STAFF RECOMMENDATION
3800 Princeton Ave
September 19, 2018

Application: New Construction - Addition
District: Richland-West End Neighborhood Conservation Zoning Overlay
Council District: 24
Map and Parcel Number: 104050158.00
Applicant: Matthew McCrary, Allard Ward Architects
Project Lead: Jenny Warren, jenny.warren@nashville.gov

<p>Description of Project: Application is for a rear addition.</p> <p>Recommendation Summary: Staff recommends approval with the following conditions</p> <ol style="list-style-type: none">1. Staff approve the roofing color, the side step material, the windows and the doors, prior to purchase and installation;2. The clay ridge tiles shall be retained; and,3. The HVAC shall be located behind the house or on either side, beyond the mid-point of the house; <p>finding that the project meets II.B of the <i>Richland-West End Neighborhood Conservation Zoning District: Handbook and Design Guidelines</i>.</p>	<p>Attachments</p> <p>A: Photographs B: Site Plan C: Elevations</p>
--	---

Figure 4: East elevation with proposed window

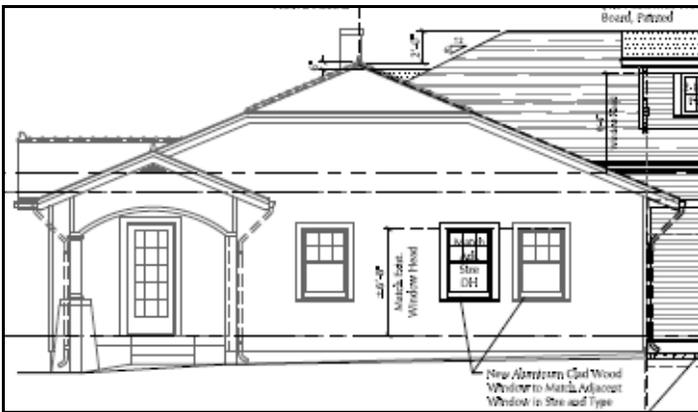
Further partial demolition will occur on the east elevation, where a small section of wall will be removed to add a window (Figures 3 and 4). Staff finds that this fenestration change is also appropriate as it is located beyond the midpoint of the historic house and the new window will match the design and dimensions of existing windows.

Figure 5: West elevation

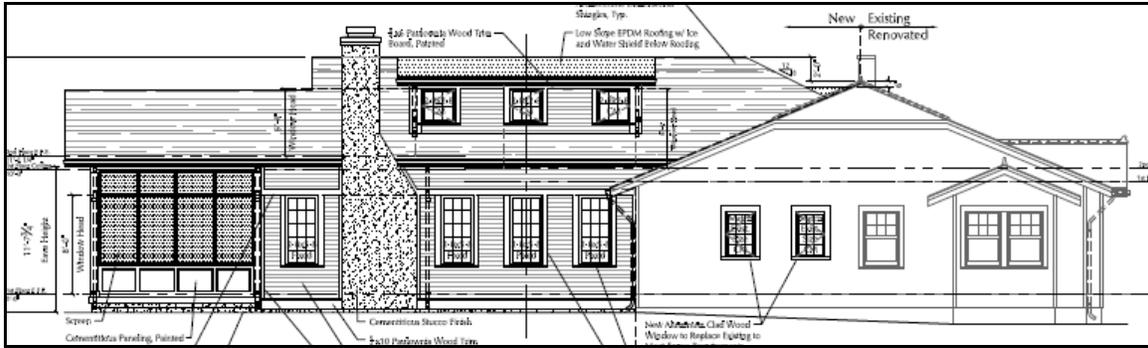
Height & Scale: The proposed addition is narrower than the historic house. On the west side the addition is inset by two feet (2') as per the guidelines, and on the east side, it is inset about nine feet, six inches (9'6").

The historic house is about thirty-six feet (36') deep, and the addition will add about forty-two feet (42') of increased depth. While the increased depth is significant, staff finds that the overall depth could be appropriate, as the house itself is shallow when compared to the historic context. Also, approximately ten feet (10') of the depth is comprised of a semi-open screened porch.

The historic house has a side gabled roof, with a ridge approximately seventeen feet (17') above the finished floor height. The addition hips from the existing roof, and steps two feet (2') higher. The Commission has approved such roof forms in the past, finding that where a ridge raise is not possible (in this case, that is due to the clipped eaves), this type of roof is an acceptable solution. The guidelines suggest that such a height increase should only be allowed forty feet (40') back from the front wall of the house, and in this instance the height increase occurs at about thirty-two feet (32') back. Staff finds that to be appropriate in this instance, as the historic house itself is only about thirty-six feet (36') deep. The project meets section II.B.1.a. and b.

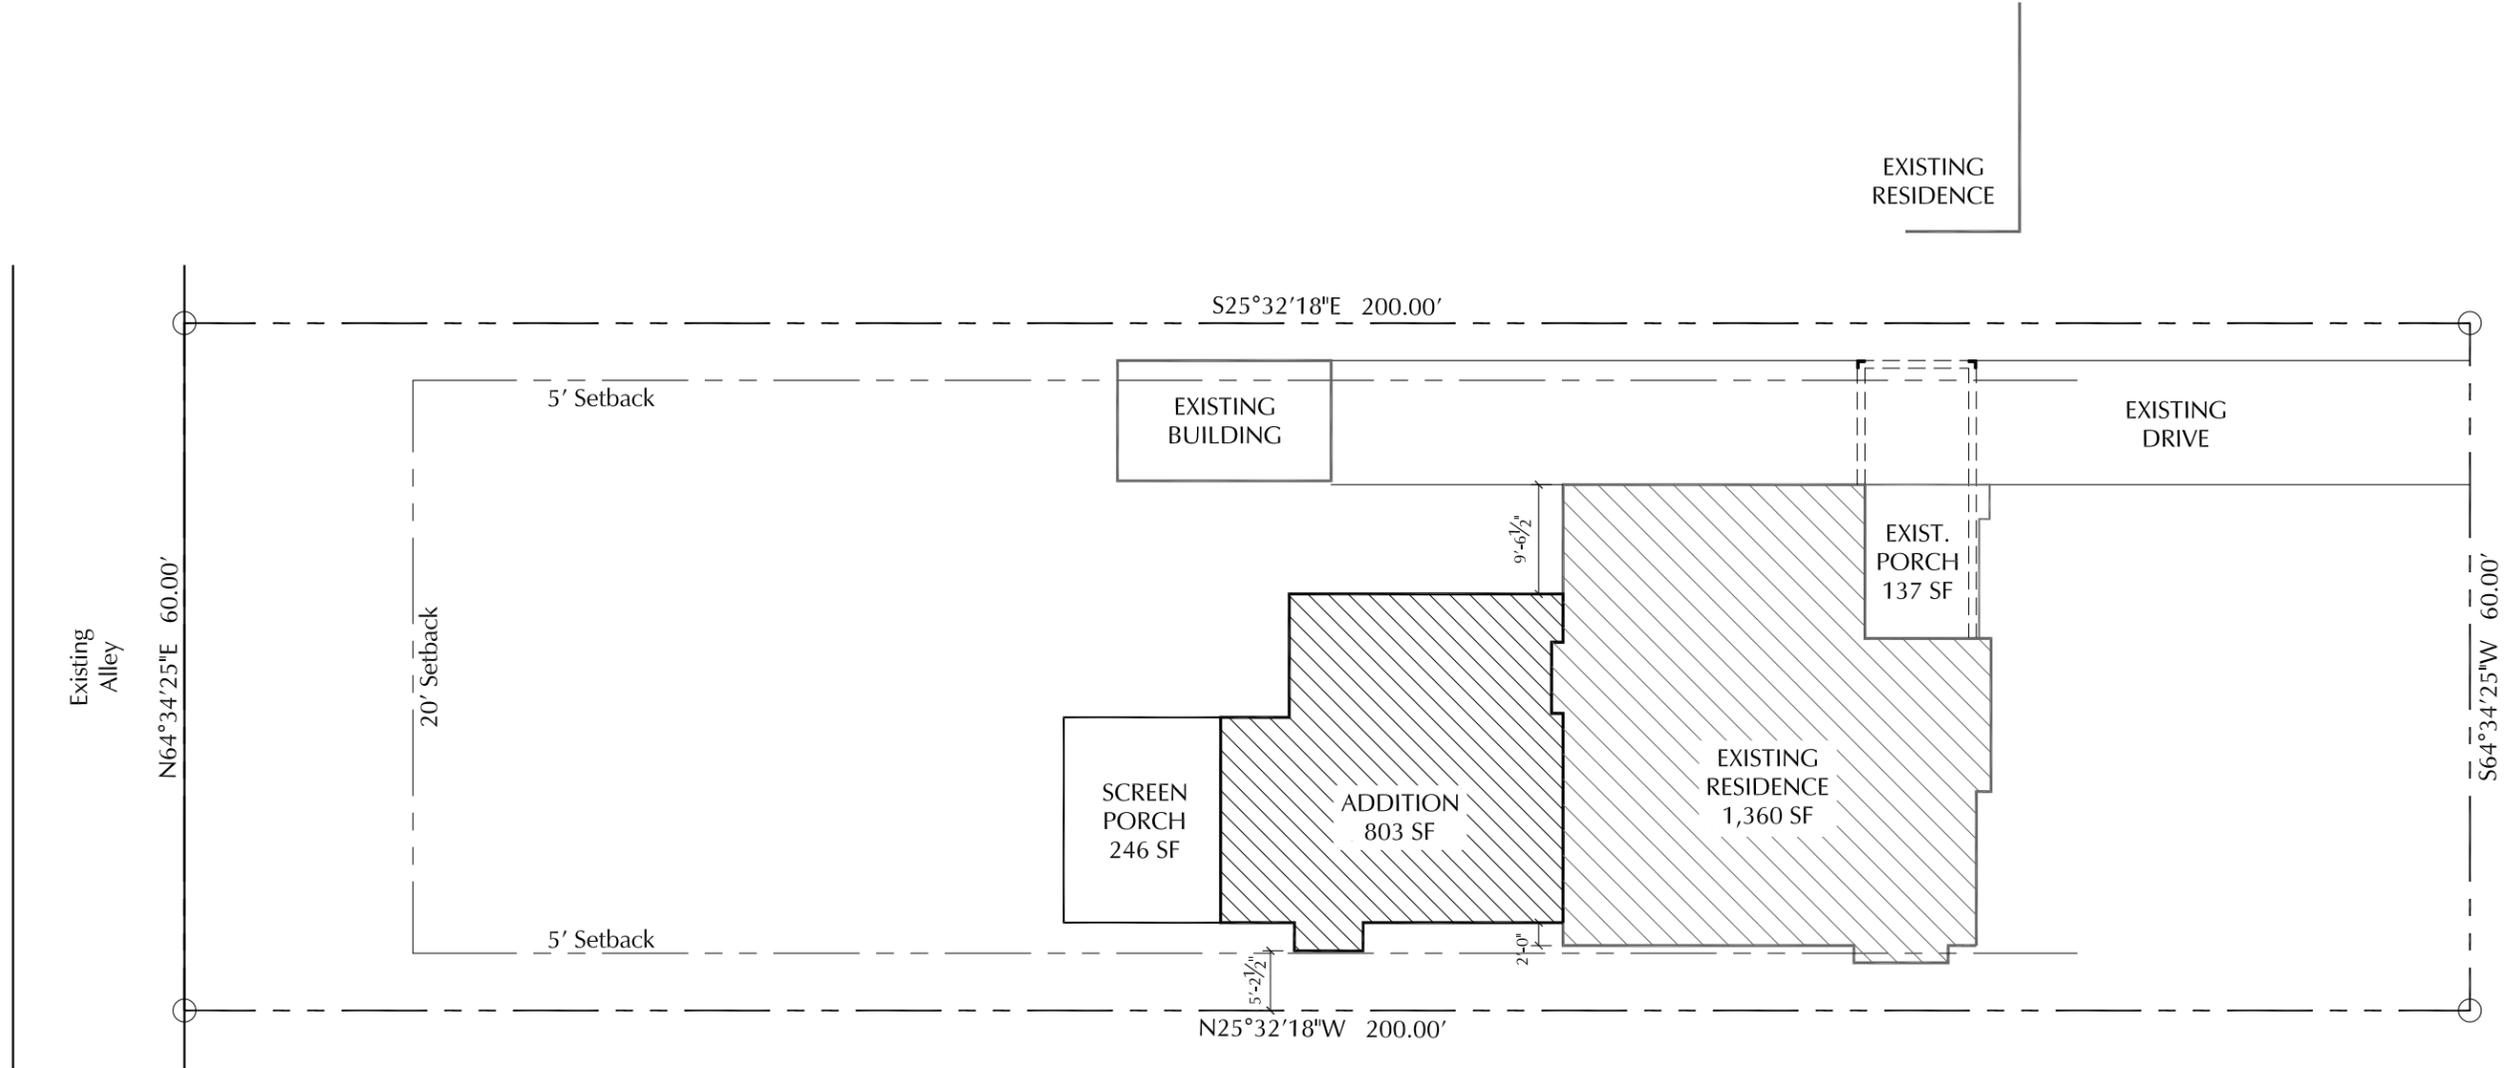
Proportion and Rhythm of Openings: No changes to the window and door openings on the existing house were indicated on the plans, beyond the window being added to the east elevation, as discussed under “demolition.” The majority of the windows on the

ground floor of the proposed addition are generally twice as tall as they are wide, thereby meeting the historic proportions of openings. On the east elevation, smaller square windows flank the side door, staff finds these to be appropriate as they are beyond the midpoint of the house and are accent windows. Smaller square windows are also found in the dormers. Staff finds these to be appropriate as this type of smaller window is typical of dormers in historic houses. There are no large expanses of wall space without a window or door opening. Staff finds the project's proportion and rhythm of openings to meet Section II.B.1.g.

2 Rear Elevation
 Scale: 1/8"=1'-0"

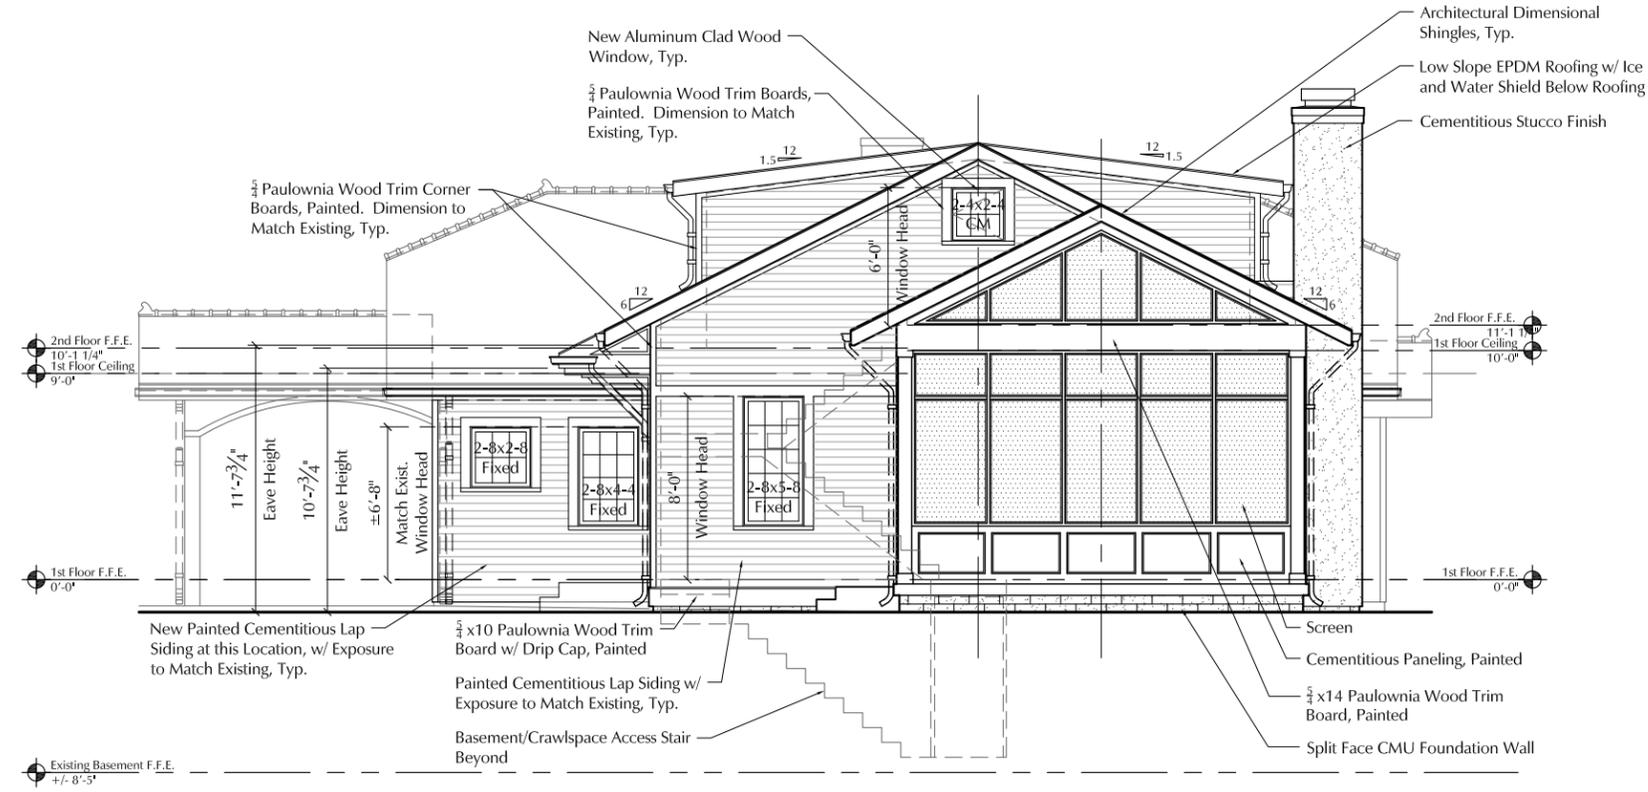
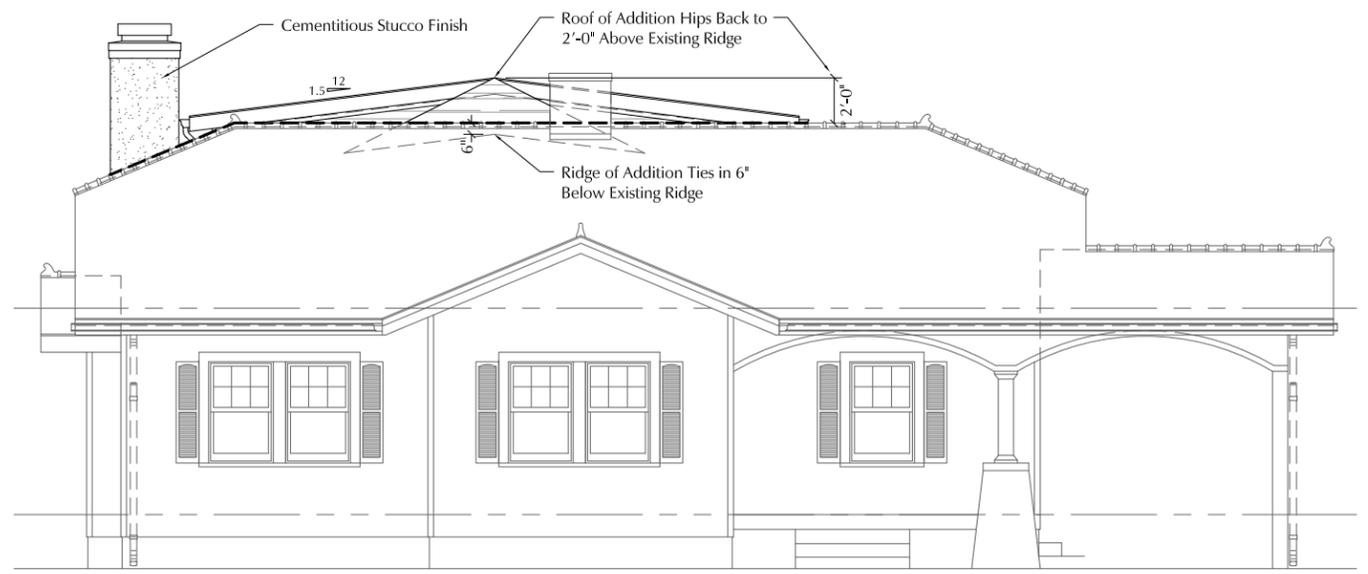
Demolition: Partial demolition will occur on the rear elevation of the structure, including removing a portion of the back slope of the side gabled roof, to allow for the addition to tie into the existing roof (Figure 2) and removal of the rear deck. Staff finds that this partial demolition is appropriate because this portion of the house is not visible from the public right of way and does not contribute to the historic or architectural character of the building.

The historic house has a side gabled roof with clipped eaves and clay ridge tiles. The roof form of the proposed addition leaves this primary roof form intact. Staff would request that the ridge tiles be retained, as they are a character-defining feature of the house. The project meets section II.B.2.a and e.

Roof form: The historic house has a side-gabled clipped roof form with a 5/12 slope. The proposed addition has a rear gabled roof form that hips into the back of the side gabled roof. The rear gable has a 6/12 slope. The dormers on either side have a 1.5/12 slope. The new roof is two feet (2') higher than the historic roof, as noted above. Staff finds that the roof form and slope of the addition are compatible with the historic house.

1. Staff approve the roofing color, the side step material, the windows and the doors, prior to purchase and installation;
2. The clay ridge tiles shall be retained; and,
3. The HVAC shall be located behind the house or on either side, beyond the midpoint of the house;
